HISTORIC AND DESIGN REVIEW COMMISSION

HDRC CASE NO: 2018-345
ADDRESS: 2209 N ST MARYS
LEGAL DESCRIPTION: NCB 1735 BLK 14 LOT 14
ZONING: C-3NA,H
CITY COUNCIL DIST.: 1
DISTRICT: Tobin Hill Historic District
APPLICANT: Davis Sprinkle/Sprinkle & Co.
OWNER: Urban Grid LLC
TYPE OF WORK: Exterior modifications
APPLICATION RECEIVED: June 29, 2018
60-DAY REVIEW: August 28, 2018
REQUEST:

The applicant is requesting a Certificate of Appropriateness for approval to:

2209 N. St. Mary's Site Plan

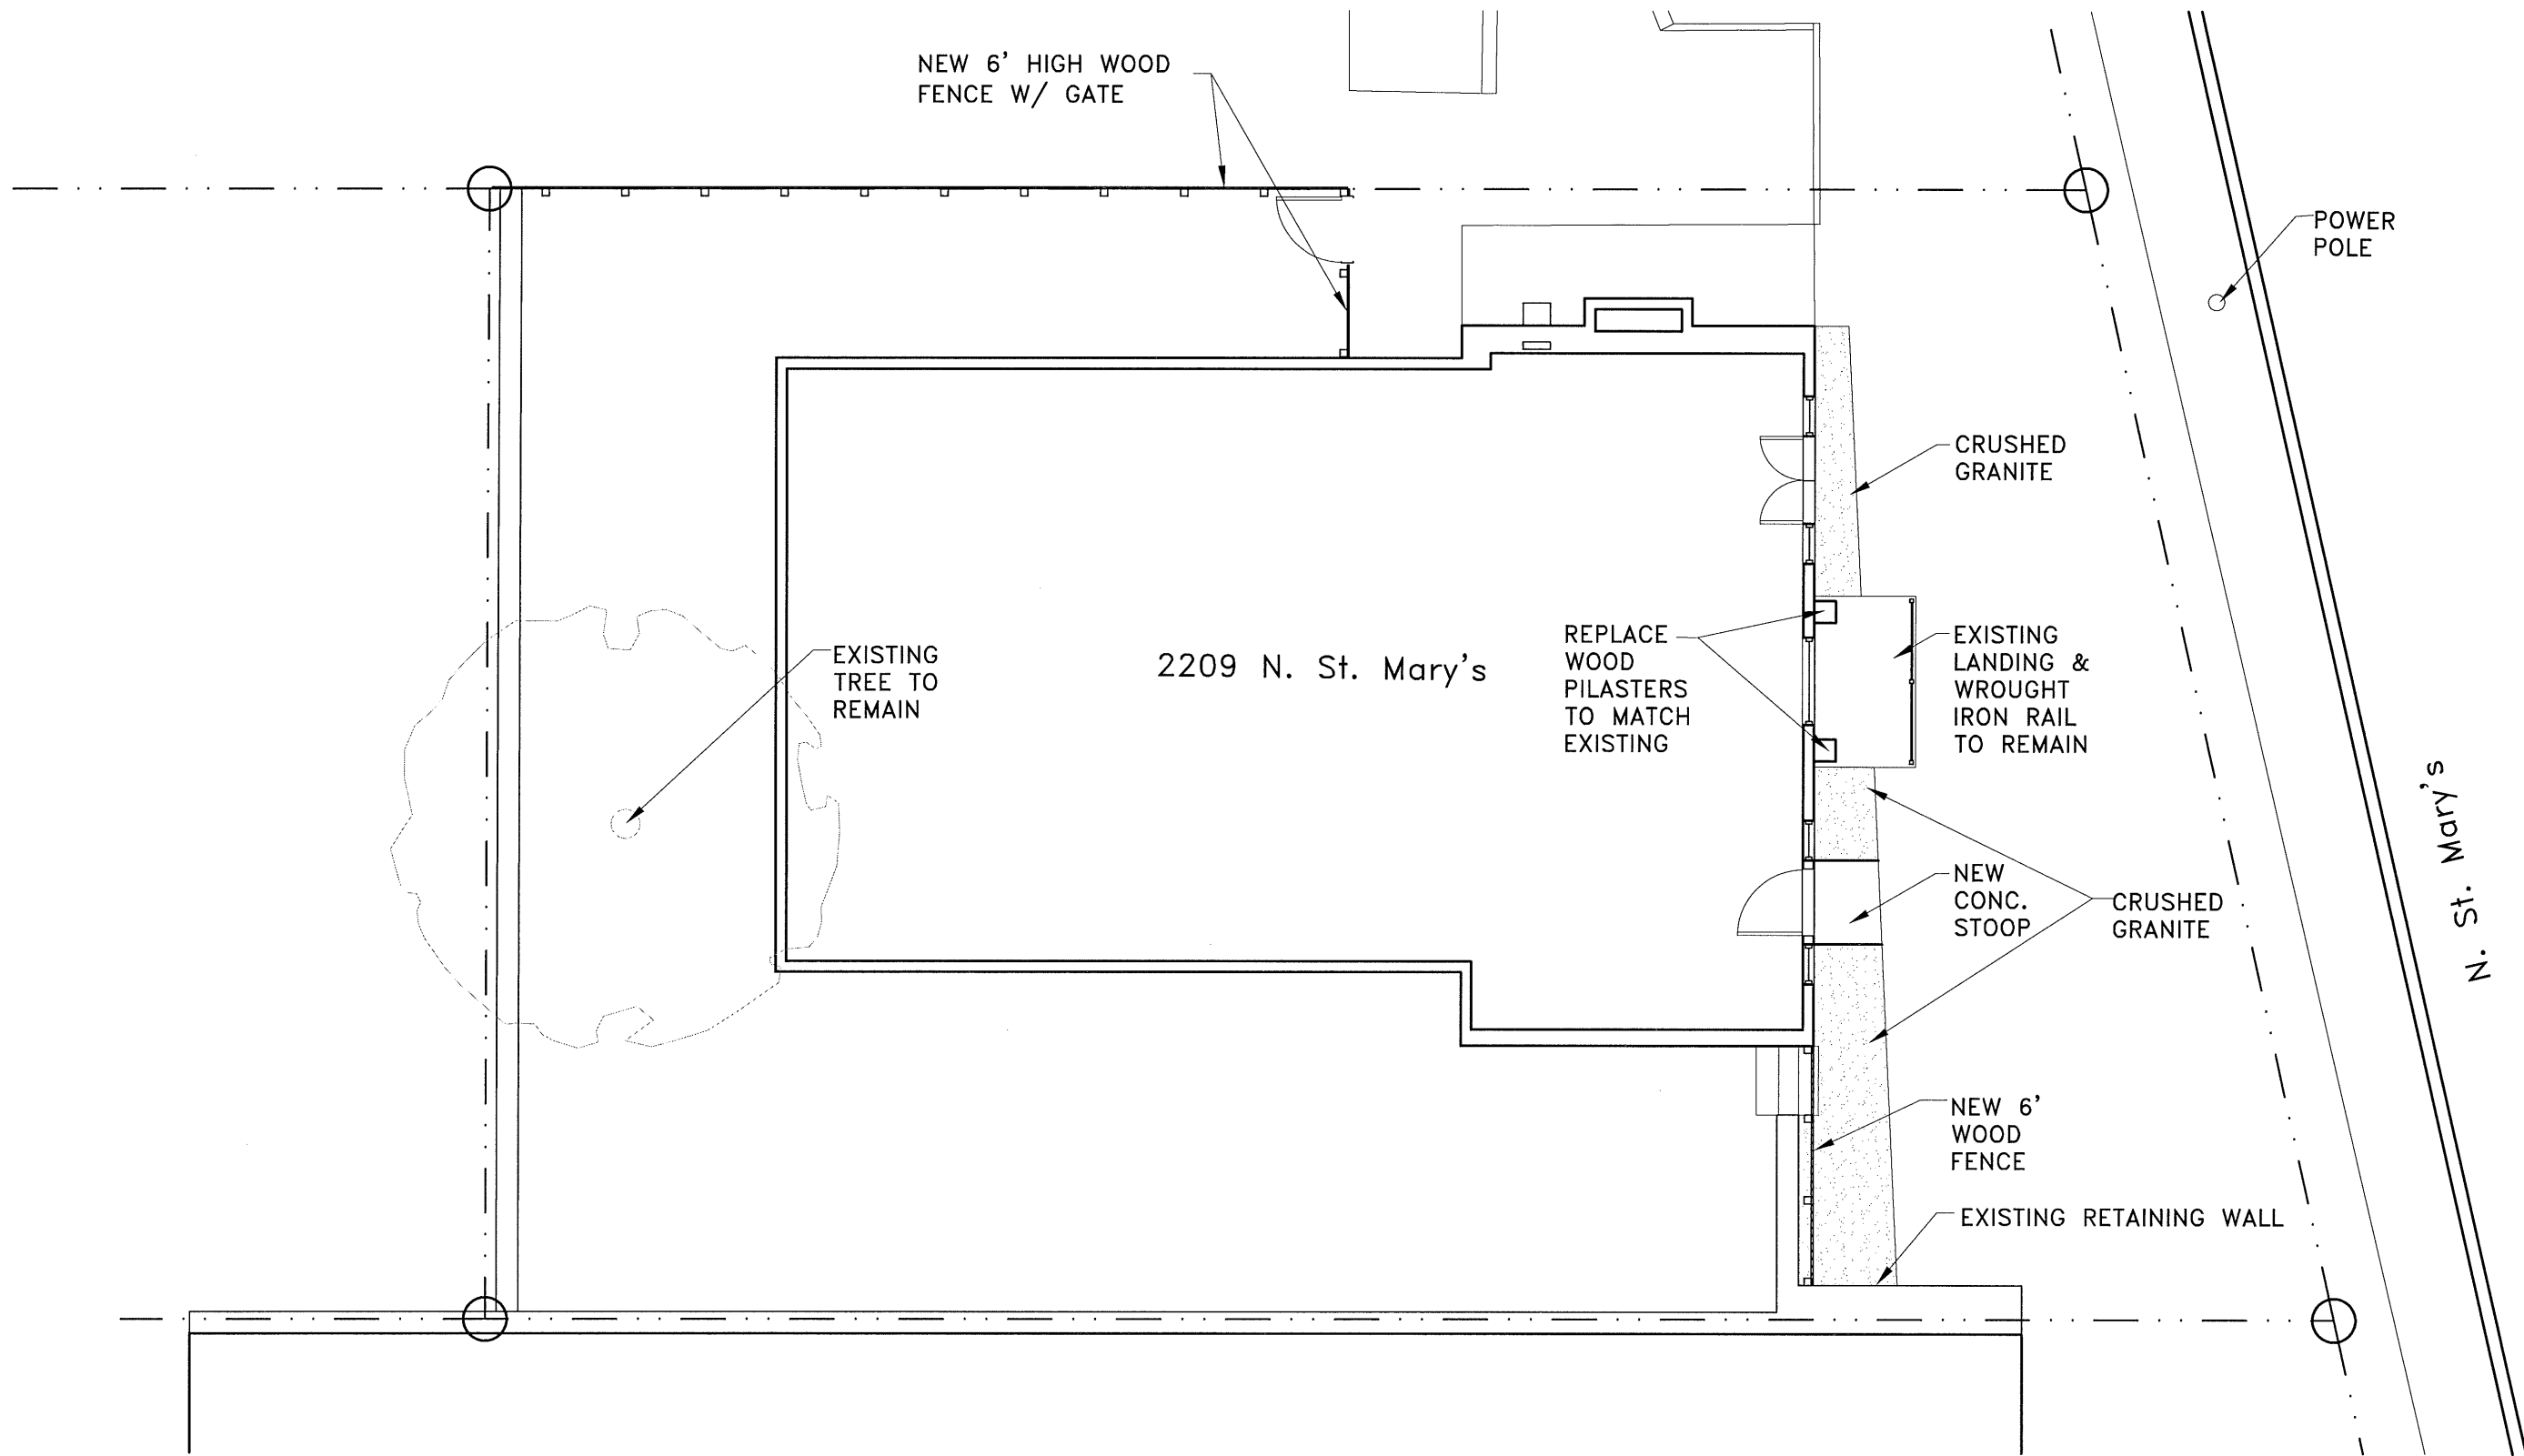
- b. **CENTRAL FRONT DOOR MODIFICATIONS** – The applicant has proposed to replace an existing front door with a new fixed wood window. The window will be a single panel and will not feature divided lites. According to the Historic Design Guidelines, new windows should match the historic windows in terms of size, type, configuration, material, form, appearance, and detail when original windows are deteriorated beyond repair or missing. Historically, windows on this style of home and of this size featured multiple divided lites, and there are several examples within the district and across the city of homes that have retained this character defining detail. Staff finds that a new window installed in this location should feature divided lites based on its location and size.

- c. **SIDE FRONT DOOR MODIFICATIONS** – The applicant has proposed to install salvaged French doors in the two side openings on the first floor of the front façade. Presently, the southernmost opening features a single door with fixed side lites and window stools. The northernmost opening features a pair of wide solid doors. The applicant has proposed to retain the southernmost door opening configuration and install a single salvaged wooden door with multiple lites. The applicant has proposed to retain the overall size of the northernmost opening, but install a French door with side lites with multiple lites. According to the Historic Design Guidelines, existing opening should be retained. Replacement doors and windows should match the size, material, and profile of historic elements. Staff finds the proposal appropriate for the structure.

- e. **FRONT PORCH MODIFICATIONS** – The applicant has proposed to install new wooden pilasters on the first floor to match the existing historic pilasters on the second floor. The new pilasters will flank the central opening of the structure. According to the Historic Design Guidelines, pilasters should be replaced in-kind when possible. Staff finds the proposal appropriate based on the existing historic pilasters on the second floor.

- f. **NEW GUTTERS AND DOWNSPOUTS** – The applicant has proposed to install new gutters and downspouts on the front façade. The gutters will be located in the eaves and the downspouts will run on either side of the façade. Staff finds the proposal generally consistent with the stipulations listed in the recommendation.

- i. That the new wood window features a one over one configuration to be more consistent with the style of the historic structure as noted in finding c. The applicant is required to submit updated drawings that reflect this change to staff.

Item 6, Staff recommends approval of the gutter installation based on finding f with the stipulation that the applicant submits specifications to staff for approval, to include the gutter color, profile, and fastener information.
